**FINAL
SUPPLEMENTAL ENVIRONMENTAL IMPACT STATEMENT**

**SEWAGE EFFLUENT COMPLIANCE PROJECT
LOWER SANTA MARGARITA BASIN
MARINE CORPS BASE CAMP PENDLETON
SAN DIEGO COUNTY, CALIFORNIA**

DECEMBER 1998

Lemon Grove Ponds

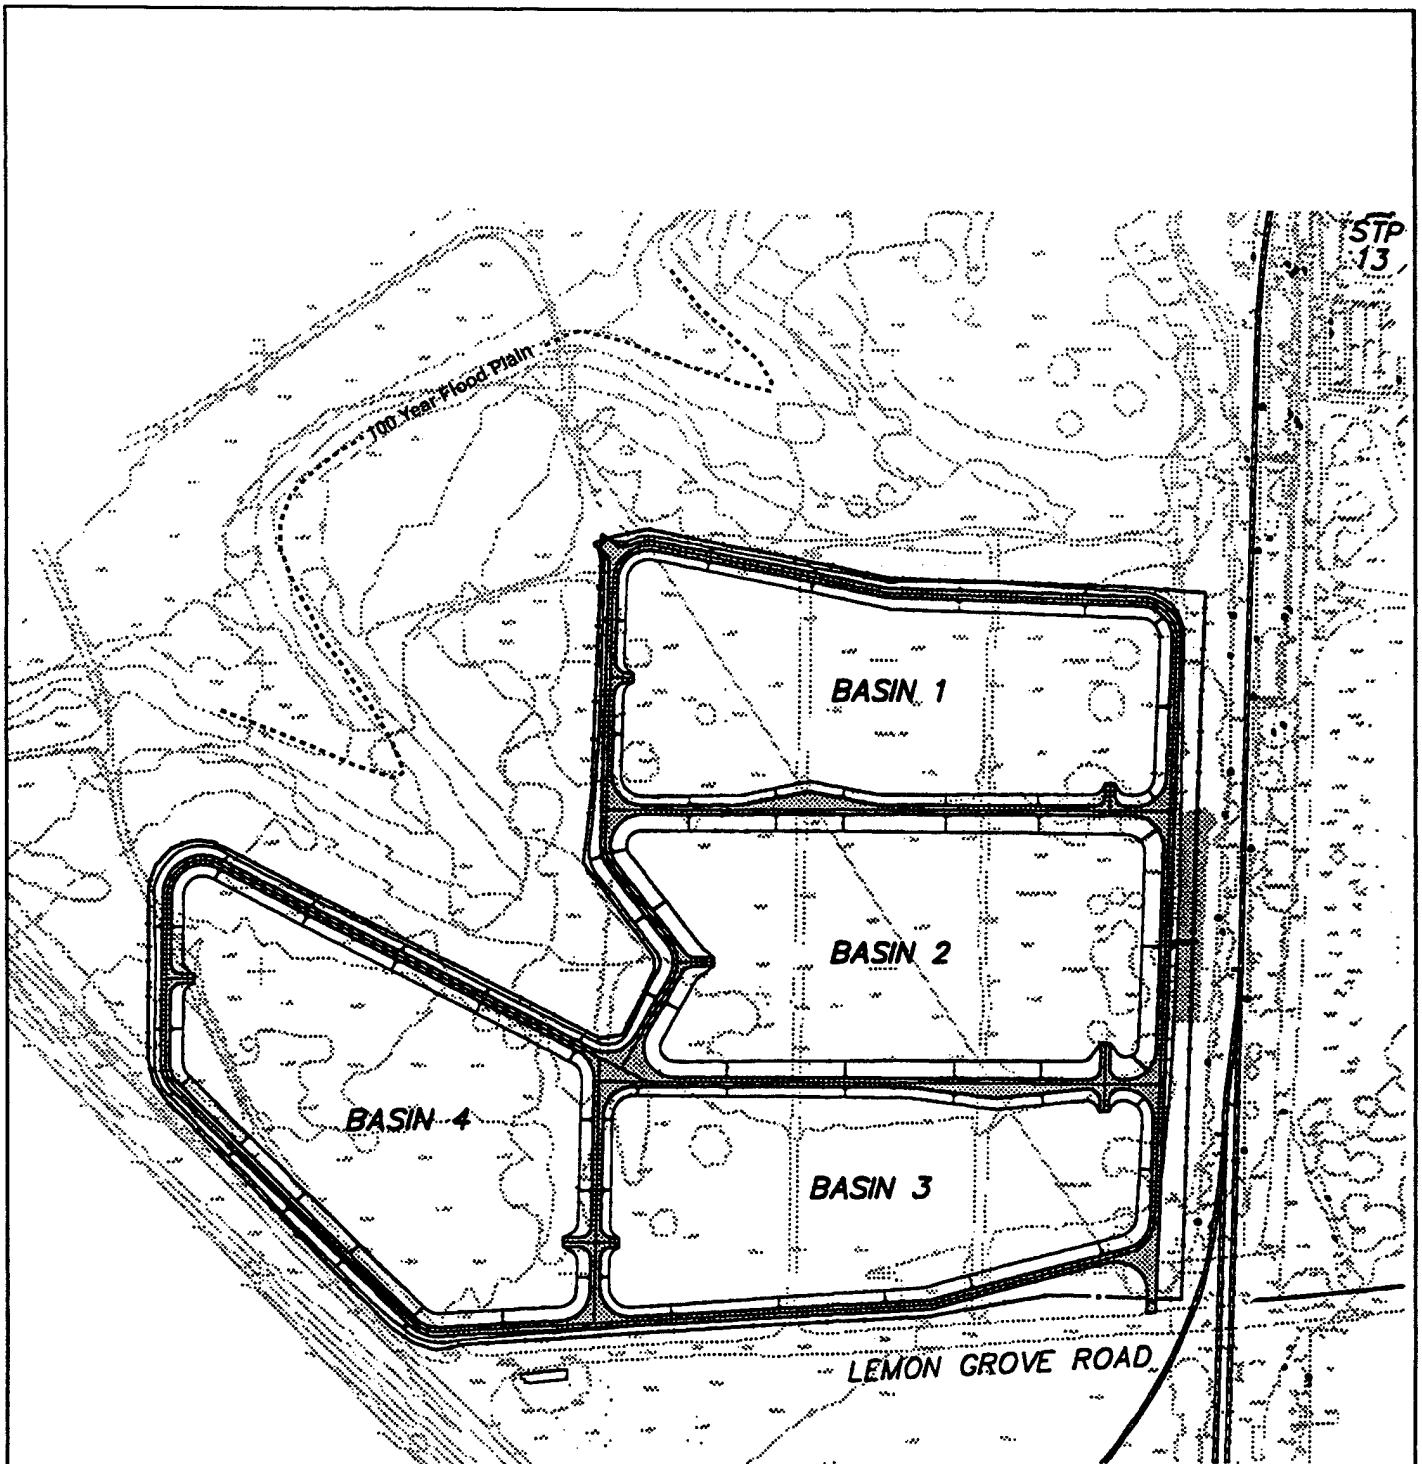
Figure 2-6, Alternative 1, Generalized Cross Section Schematic, appears misleading. Understandably, this is a generalized, conceptual, drawing; however, the text in the DSEIS states that one of the objectives of the trench would be to prevent lateral flow into the adjacent salt marsh. Yet, the drawing suggests that effluent would continue to flow into the marsh. The cross section could be much improved by using or obtaining real data and subsequently showing projected fluid flow paths.

Alternative 2 Location of Phase 2 Facilities

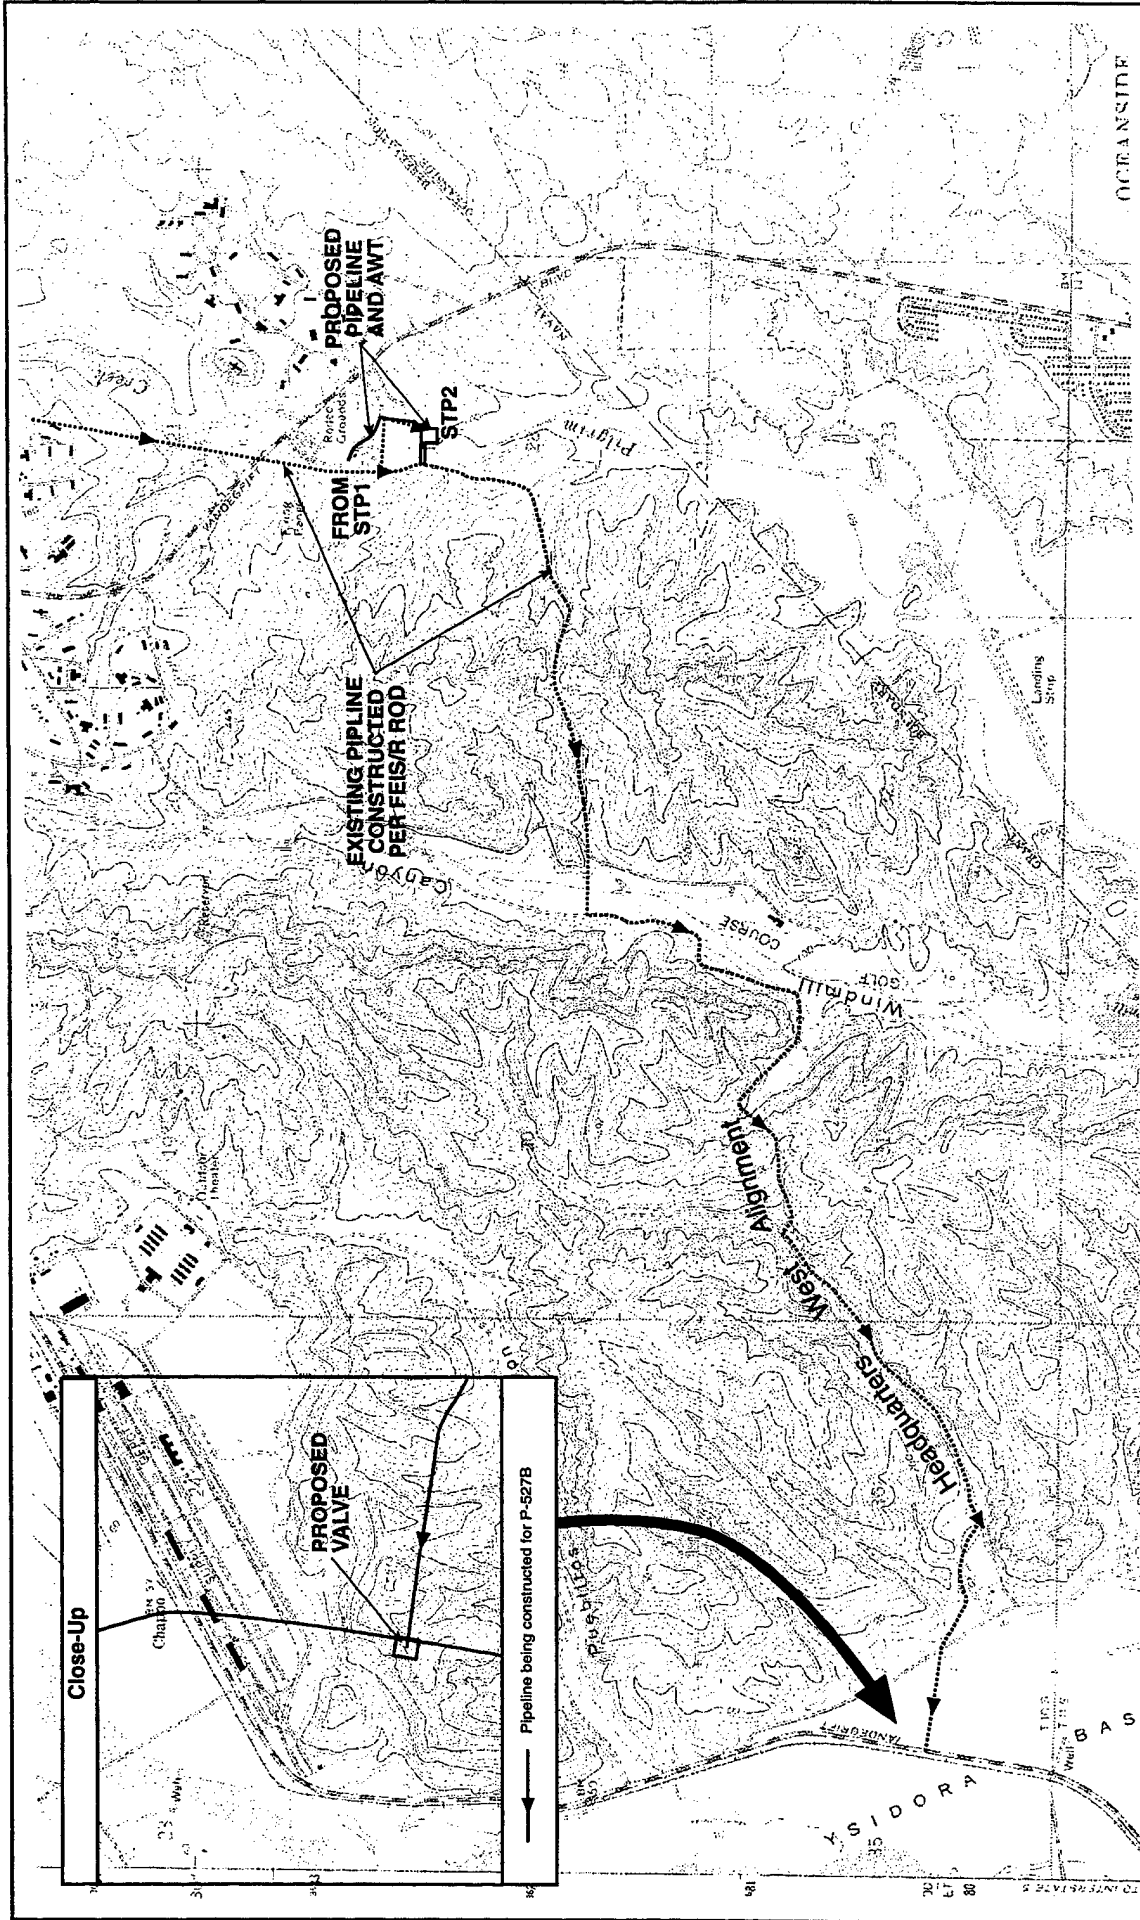
Figure 2-8, Alternative 2, Location of Phase 2 facilities. The figure and accompanying text do not clarify whether the pipeline between STP 2 and the proposed Ysidora discharge point is already constructed, authorized in the FEIS/R ROD, or is a new proposal. The FSEIS should clarify this point.

Alternative 4 Cased Wells at Lemon Grove Ponds Schematic Flow Diagram

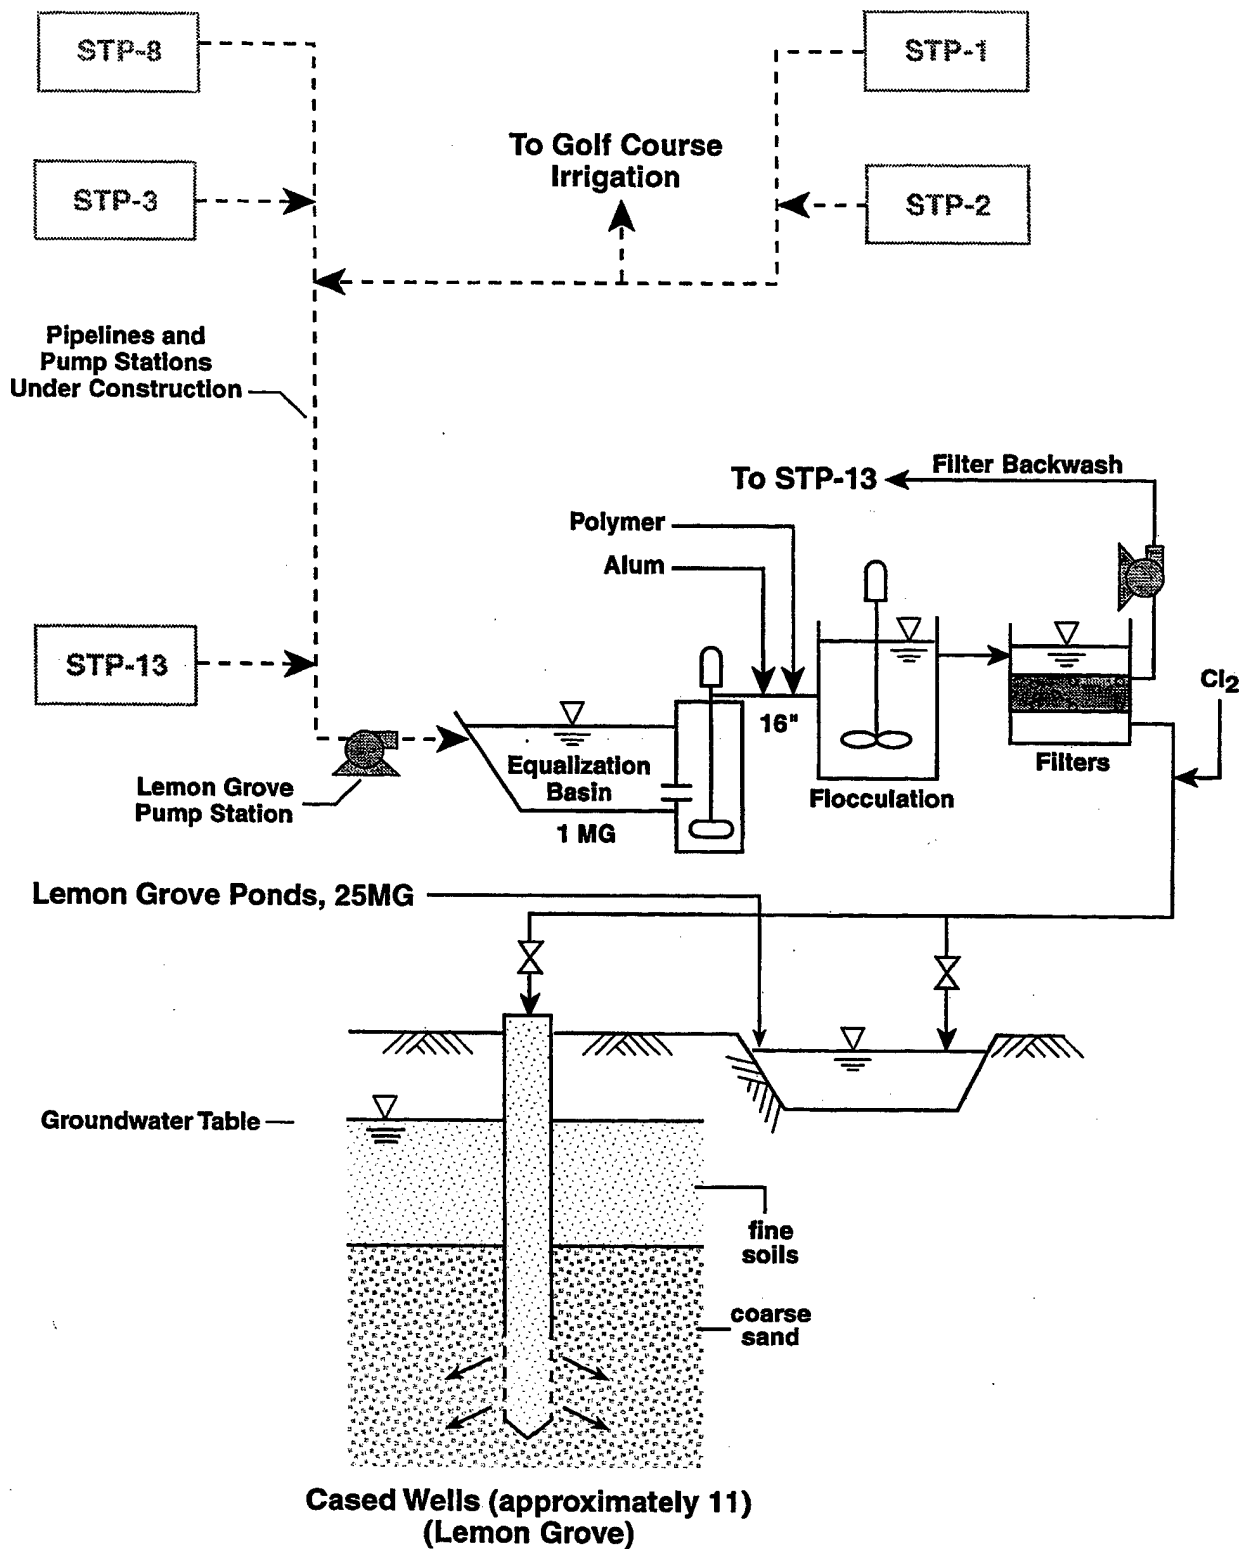
2	19	Figures 2-12 and 2-14, Schematic Flow Diagrams, respectively for alternatives 4 and 5, do not show dechlorination prior to groundwater injection. The FSEIS should indicate if this step would be included in either alternative.	Dechlorination is not proposed for alternatives 4 and 5 because chlorination is needed to prevent biomass accumulation in the proposed wells.
2	20	Figure 2-8, Alternative 2 Location of Phase 2 Facilities, and the accompanying text, do not clarify whether the pipeline between STP 2 and the proposed Ysidora discharge point is already constructed, authorized in the FEIS/R ROD, or a new proposal. The FSEIS should clarify this point.	Figure 2-10 and the accompanying text in Section 2.2.2 have been revised in the FSEIS to clarify that the pipeline from STP 2 to the Vandegrift Blvd. junction was authorized in the FEIS/R ROD. There is an existing pipeline from the junction to Ysidora Flats. Discharge to Ysidora Flats is no longer part of alternative 2.

Figures 2-12 and 2-13, Schematic Flow Diagrams, respectively for alternatives 4 and 5, do not show dechlorination prior to groundwater injection. The FSEIS should indicate if this step would be included in either alternative.
